# UNITED STATES PATENT AND TRADEMARK OFFICE

APPLICATION NO.	FILING DATE	FIRST NAMED INVENTOR	ATTORNEY DOCKET NO.	CONFIRMATION NO.
10/510,039	04/13/2005	Erich Fuderer	566/42762	4659
23646 7590 07/03/2007 BARNES & THORNBURG LLP 750-17TH STREET NW SUITE 900 WASHINGTON, DC 20006-4675			EXAMINER NGUYEN, XUAN LAN T	
			ART UNIT 3683	PAPER NUMBER
			MAIL DATE 07/03/2007	DELIVERY MODE PAPER

## Office Action Summary

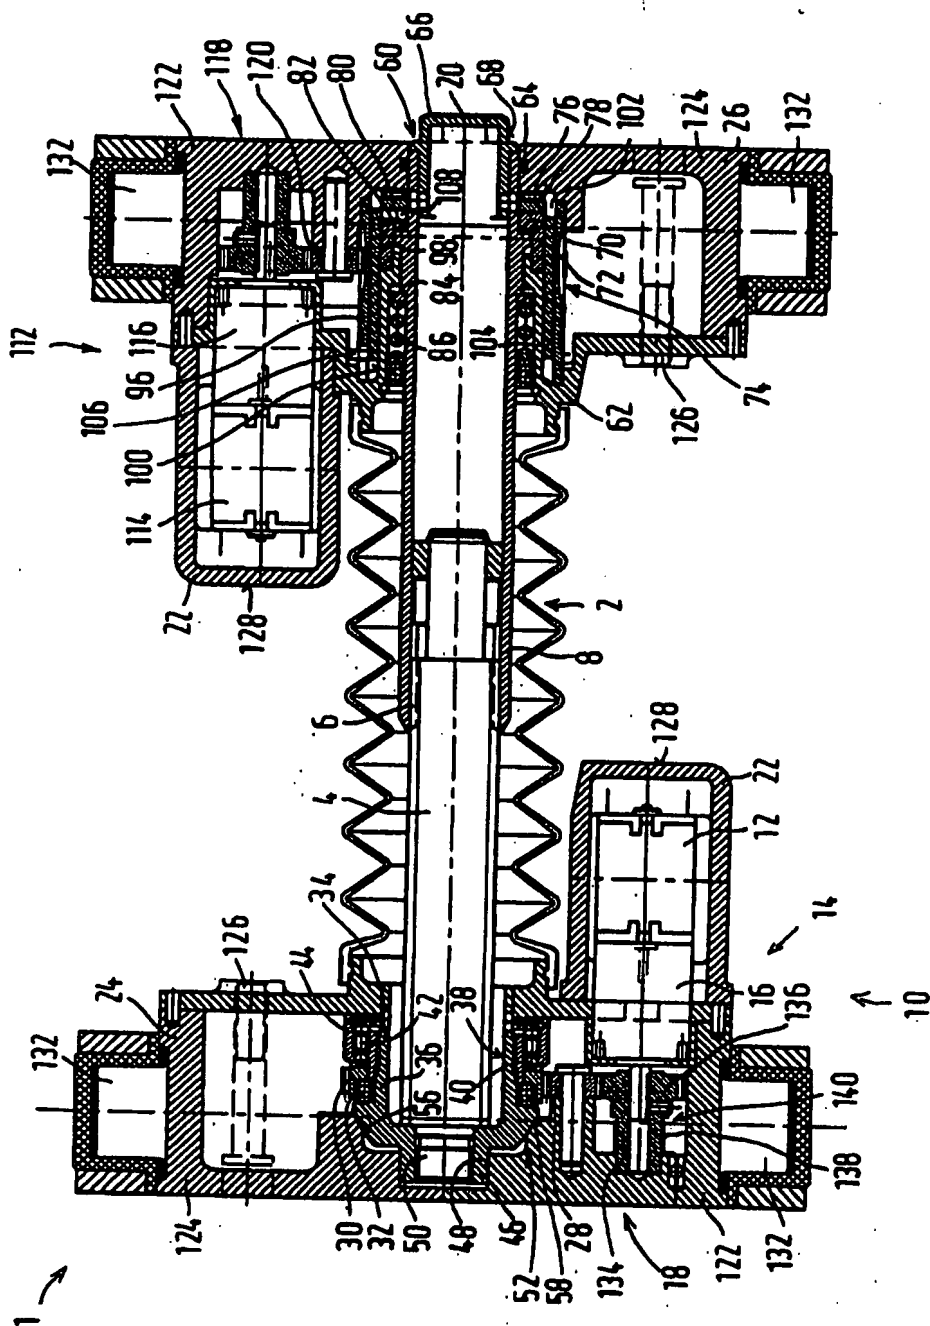
3. The drawings were received on 4/3/07. These drawings are not approved. Figures 1 and 2 are not approved because they are of poorer quality than figures 1 and 2, which are already in the file. Figure 3 is not approved because of hand written notes and there is no clear showing of contrate gearing 80 and 82. Figure 4 is not approved because of hand written notes and there is no clear showing of balls 40 and clutch 38. Furthermore, figures 3 and 4 are not exploded views. They are simply enlargements of figures 1 and 2. Because of these reason, the drawing objections are repeated above.

NOT approved

NOT approved  
5/24/07  
XCN

FIG. 3

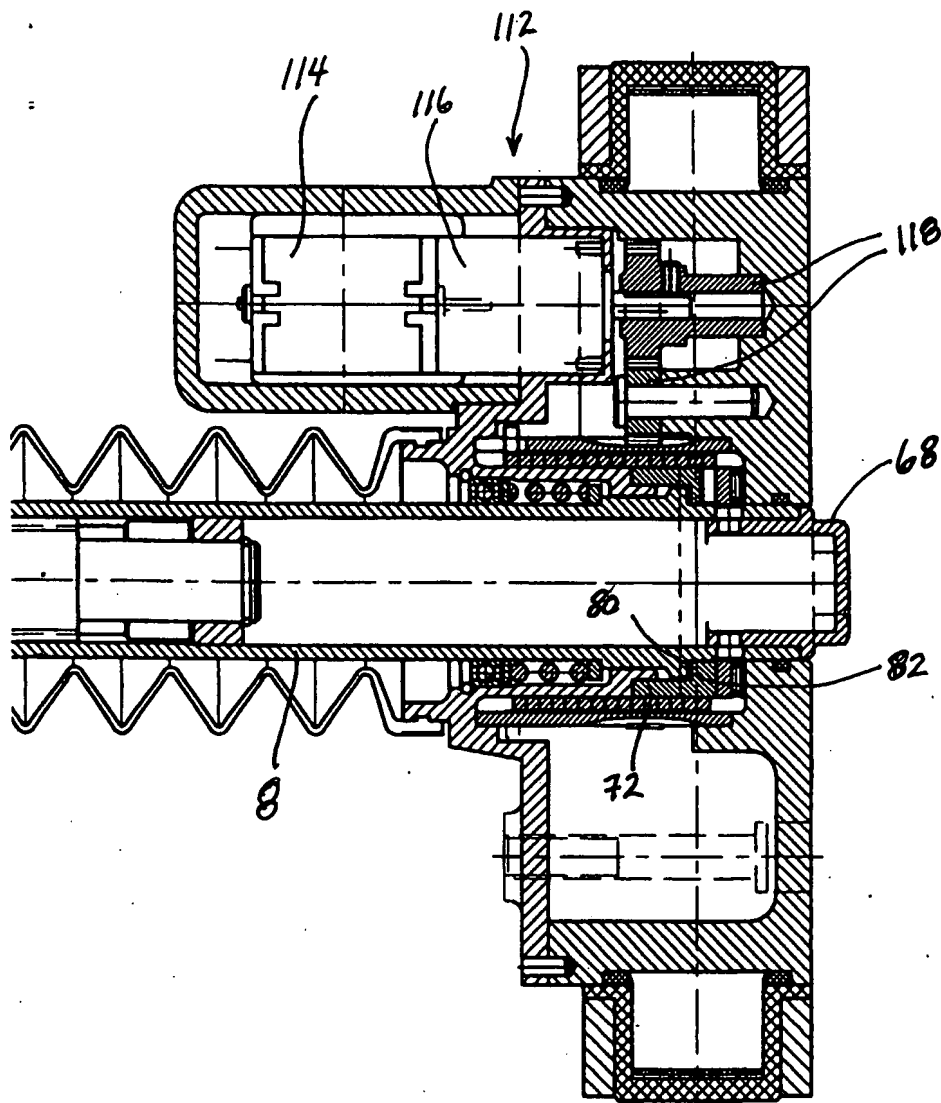
NOT approved  
XLN  
5/24/07

Erich FUDERER et al.  
10/510,039  
NEW SHEET

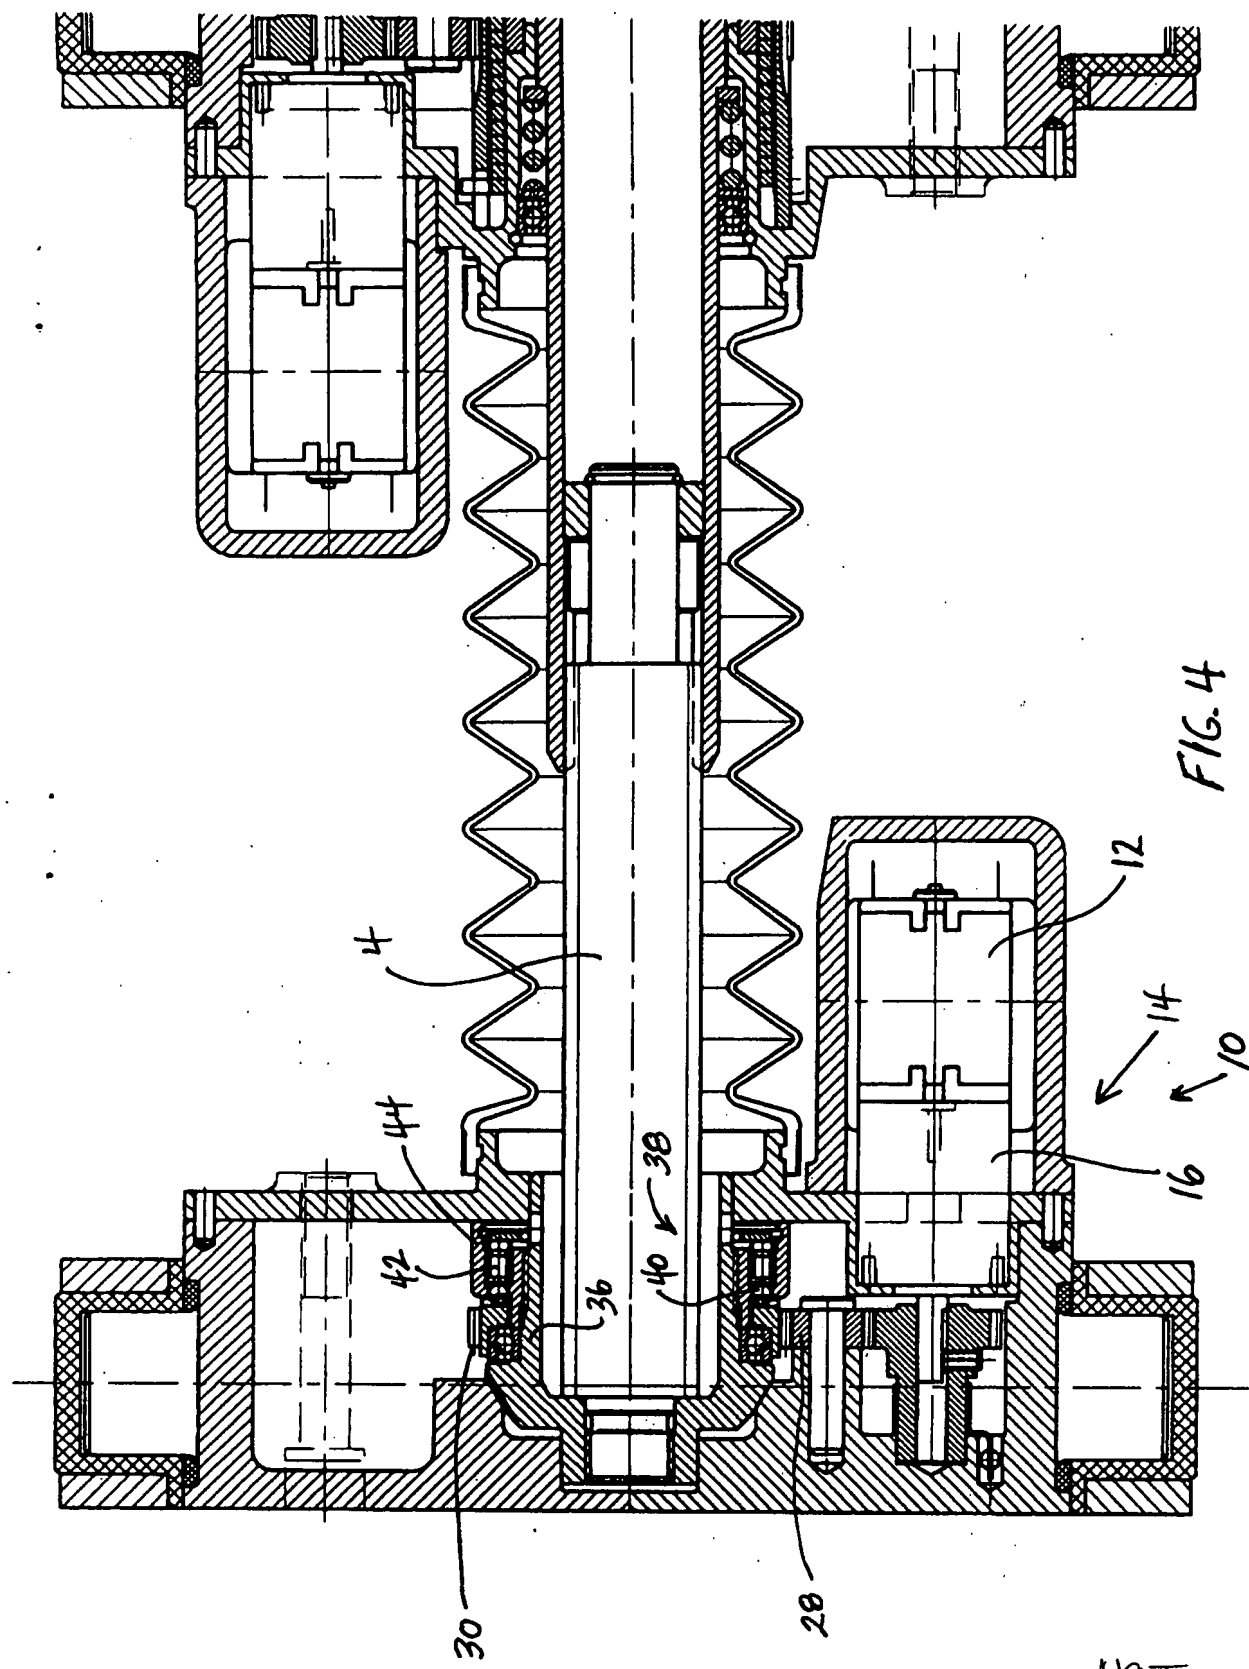
NOT approved  
XLN  
5/24/07
